AQUIND INTERCONNECTOR

Statement of Common Ground Between
AQUIND Limited and the Marine Management
Organisation

Document Ref: 7.5.16

Figure 1. Benthic baseline PSA results based on Folk Classification. No grabs returned from sampling stations 8 and 22. (taken from Figure 9, Benthic Ecology Survey Report)

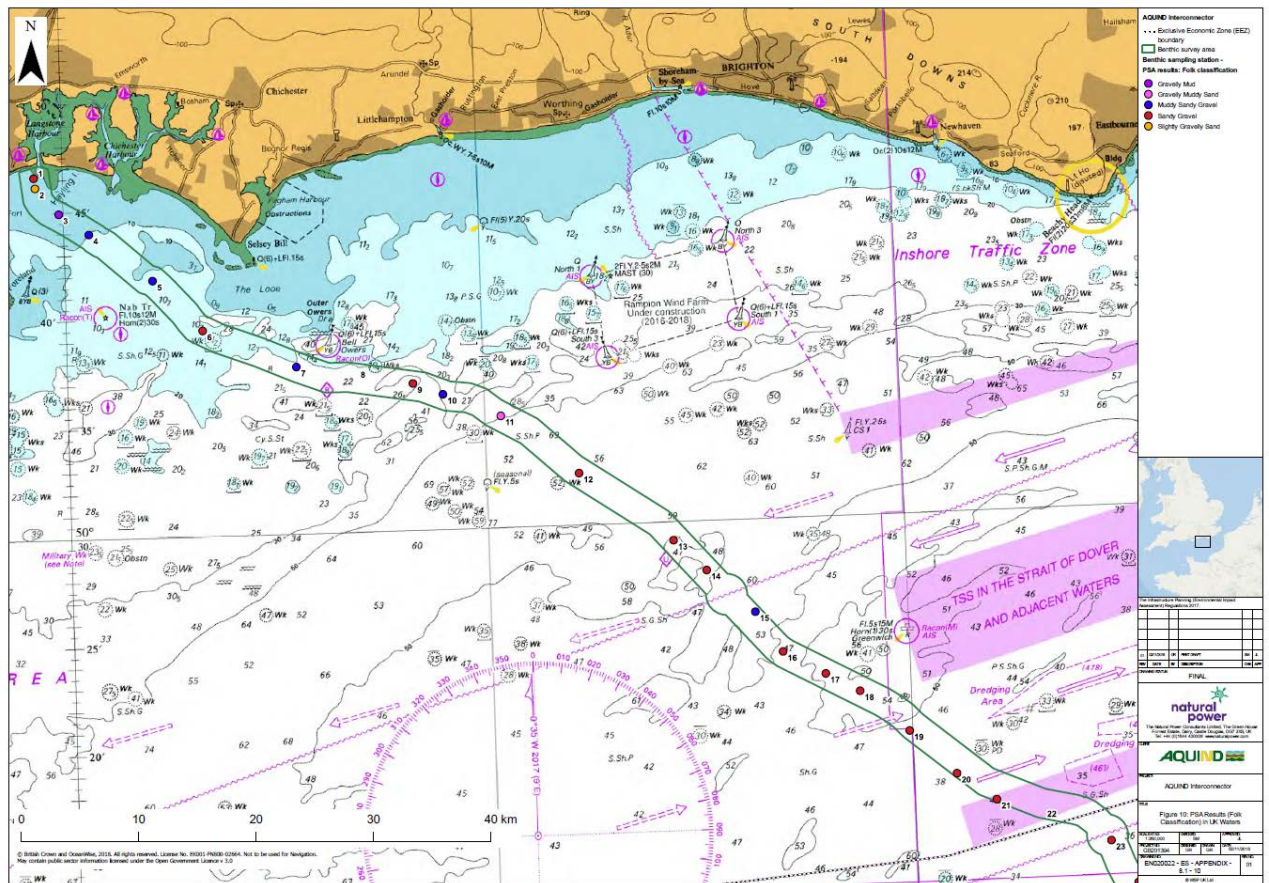
- 8.12. The applicant has noted the following in 7.4.3 (Chapter 7): “Coarse sediment has a limited affinity for sorption of chemical contaminants and therefore sediment contamination would not be expected to pose a significant risk in the offshore areas of the route given the PSD results.”

- 8.13. The point above is an acceptable premise, so long as PSD data are provided to verify that the proposed work area is appropriate. Appendix 6.3 details the grain size statistics and Appendix 8.1 details the findings of the Benthic Ecology Survey Report. Figure 1 (below) displays a map detailing the PSD of the sampling grab locations. From the location of grab station 12 up to station 23, sediment is classified as either sandy gravel or, in one instance, muddy sandy gravel. The MMO consider this acceptable evidence that sediment in the offshore segment of the cable corridor (approximately 50 km from the shore) is sufficiently coarse such that additional sample contaminant analysis is not, at this time, required.

- 8.14. In the nearshore section of the cable corridor, grab samples show a mixture of sandy gravel, gravelly mud and slightly gravelly sand, but are predominantly muddy sandy gravel. This indicates that material from the nearshore section is less consistently coarse than the offshore section. Table 1 (below) details the coordinates of the sampling locations of the sediment contaminant analysis; in order to compare how they represent the nearer shore section of the cable corridor.

For the fully functional map please see ES Addendum, Appendix 4 – Figure 2 (document reference 7.8.1.4).

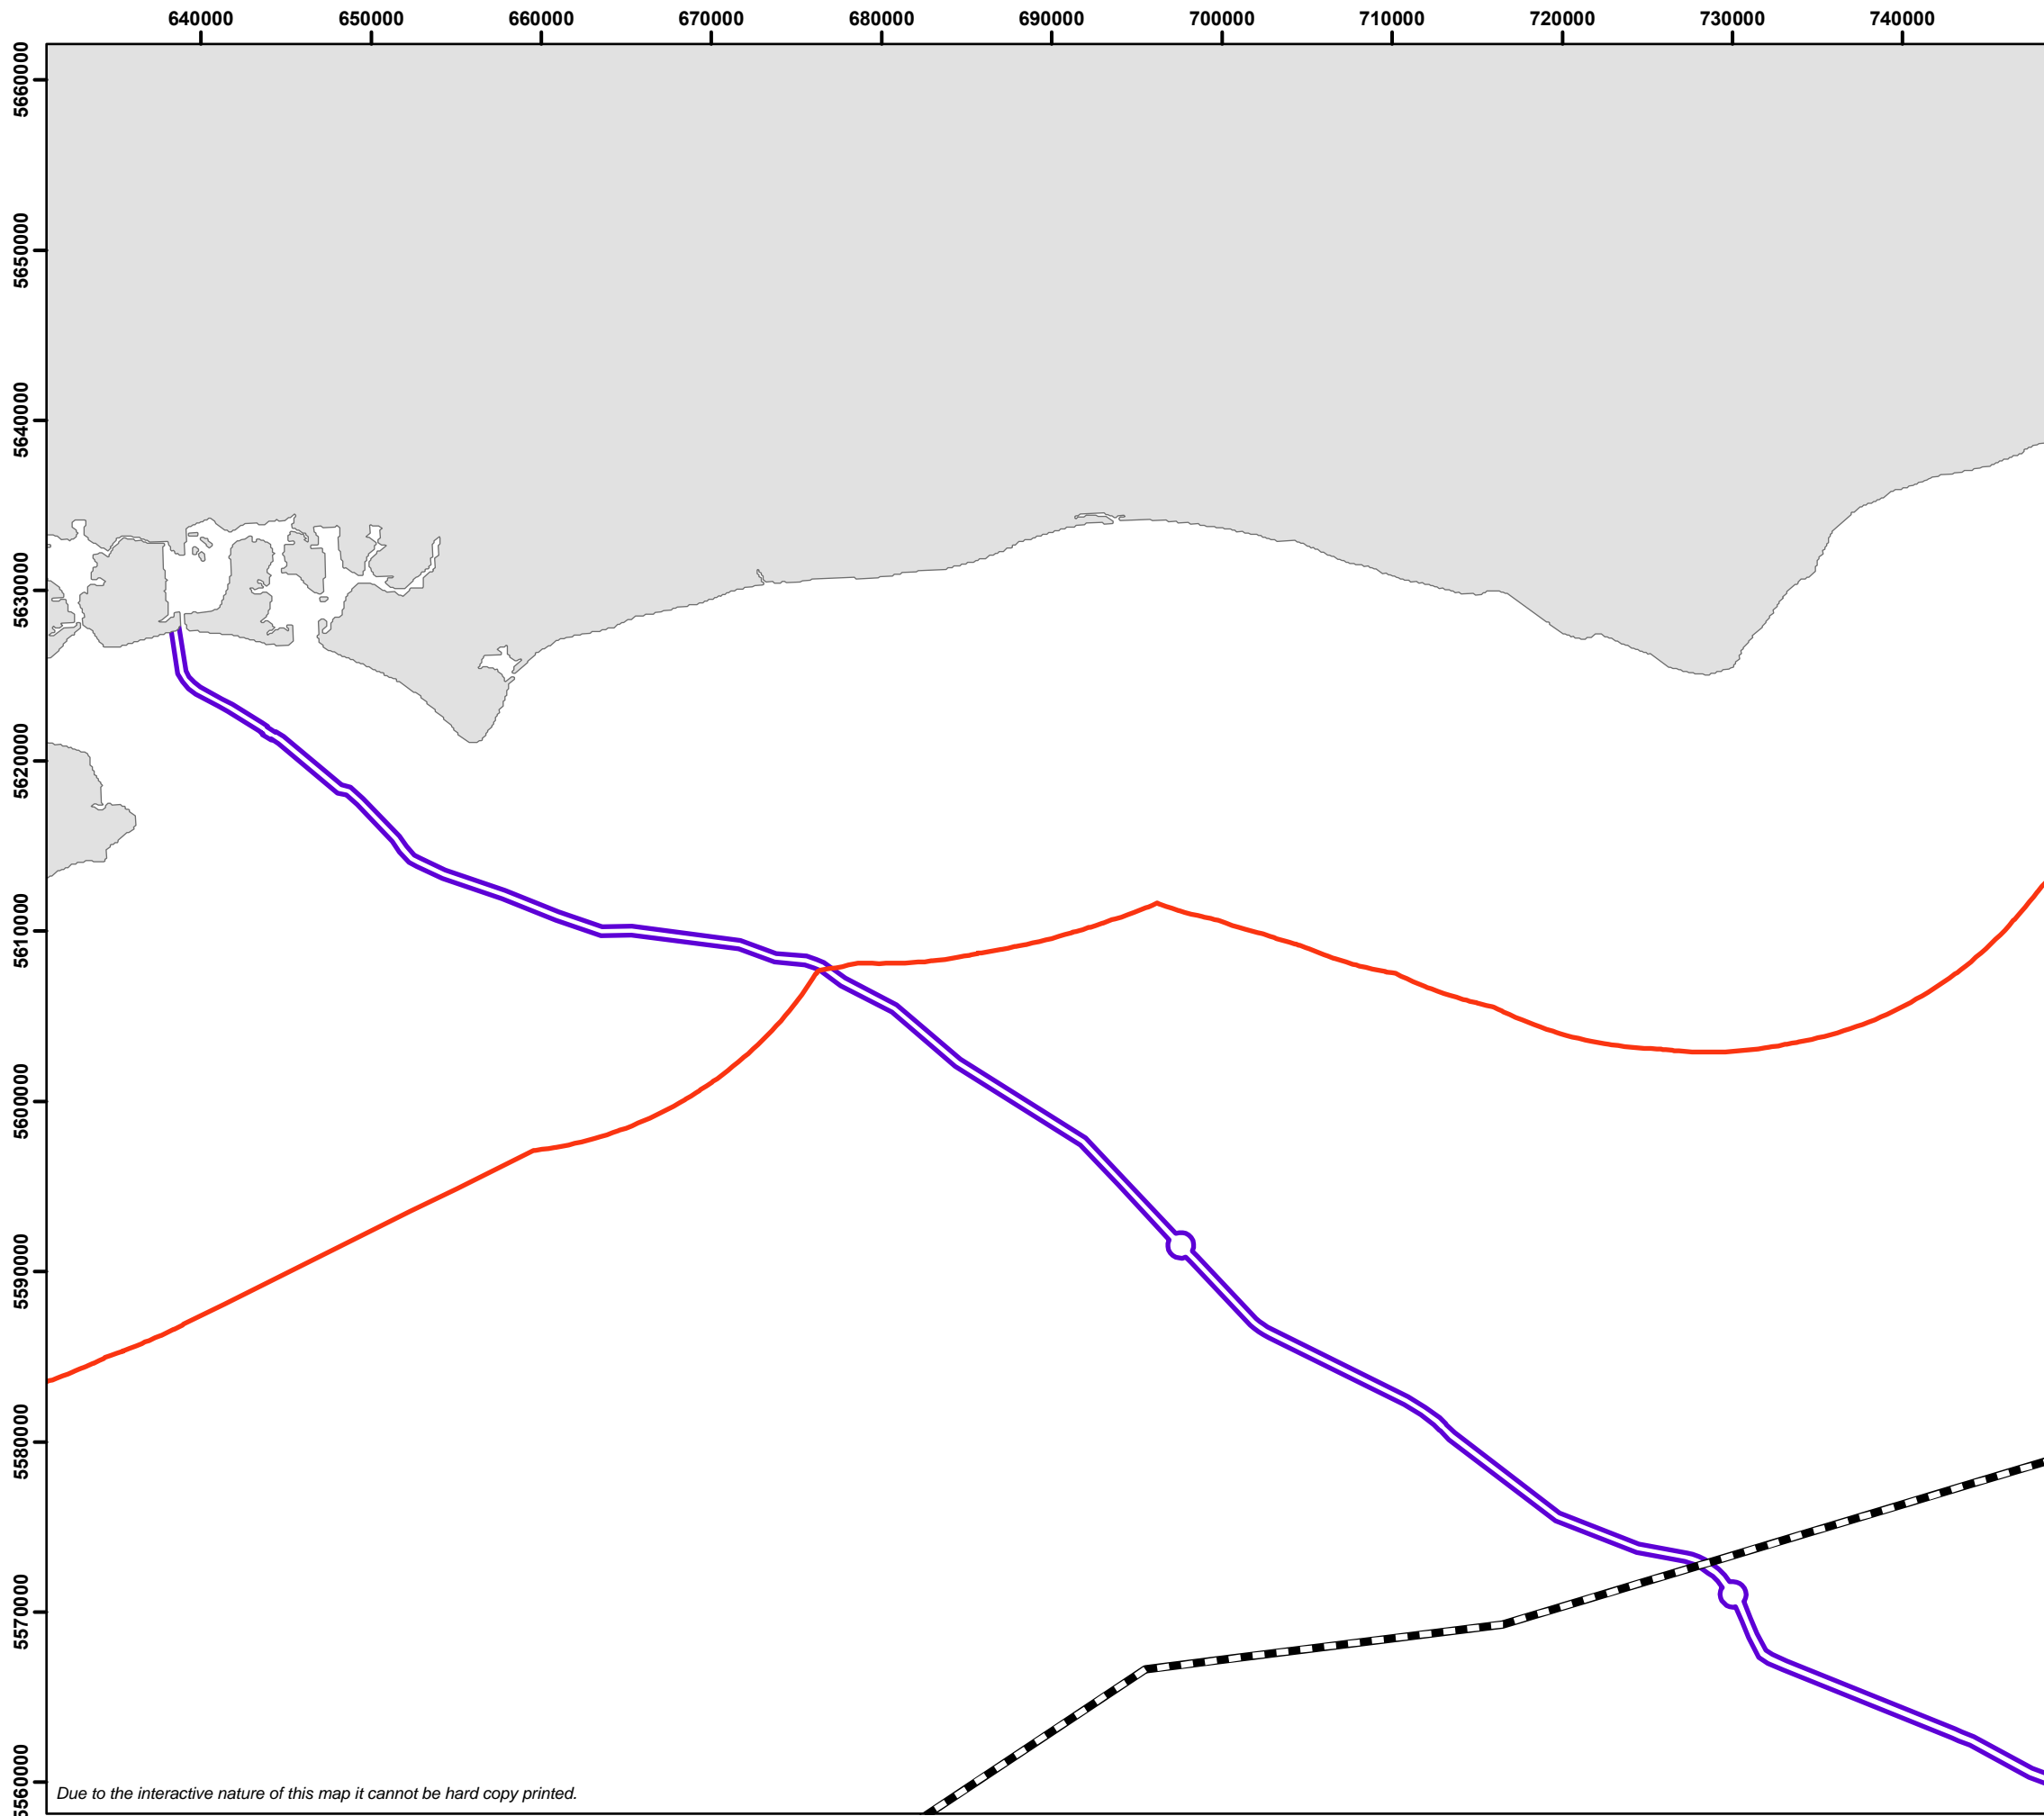
Thank you for your email dated 16 July 2020 containing an interactive PDF herring spawning map (Figure 9.10 Additional Information on Herring Spawning) which was provided following a request from The Centre for Environment, Fisheries and Aquaculture Science (Cefas).

AQUIND Interconnector – Remedial Rock Placement, First 15 Years Life

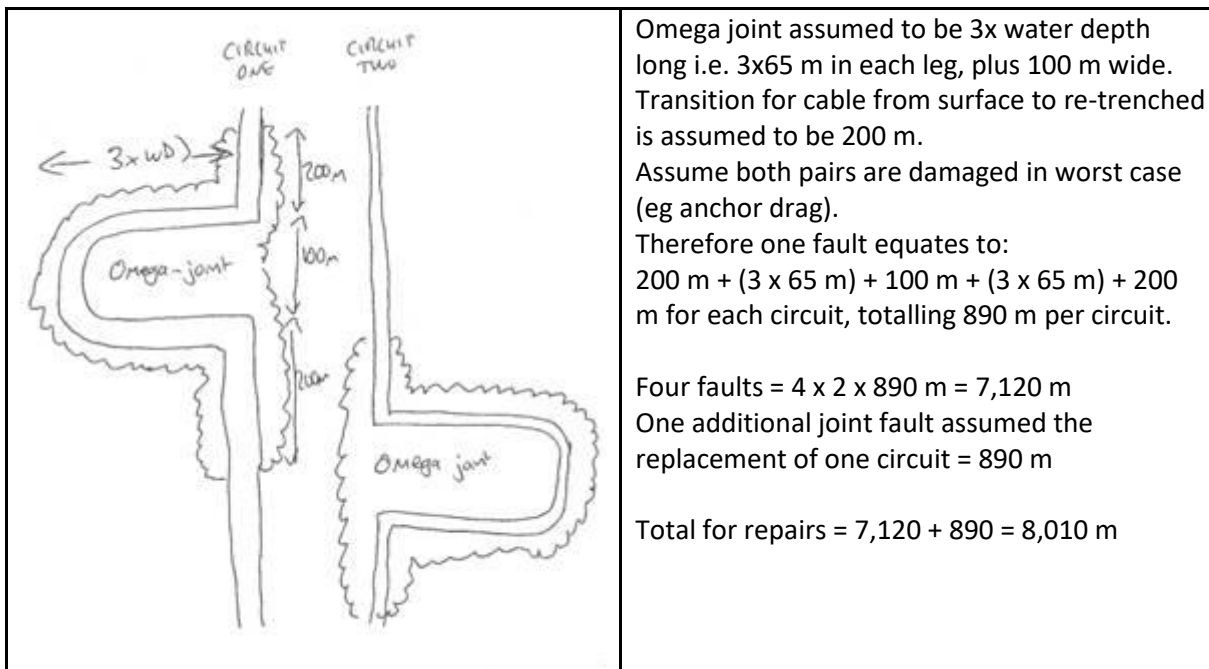
In the PEIR, AQUIND had proposed an additional 10% non-burial contingency to our worst case scenario to try and prevent incremental increases of additional cable protection through separate licences over the operational period of the project. Through our consultations on the draft deemed Marine Licence, we have been advised that the MMO seek that this contingency would only cover the first 15 years of the operational period rather than the whole lifetime of the project (40 years). You have also requested the rationale behind the contingency. I took this back to the project design engineering team who have undertaken the necessary calculations and investigations below to explain the reasoning behind the contingency. As always, we advised that they assume a worst case scenario and we think that the approach below seems reasonable. Similar to the PEIR, each technical topic is including this contingency into their worst case parameters for assessment.

I would be grateful if you and your colleagues could review the rationale below and let me know if the MMO is content with this approach. If you do not agree with this approach then we would be grateful if you could let us know why and what better approach could be taken?
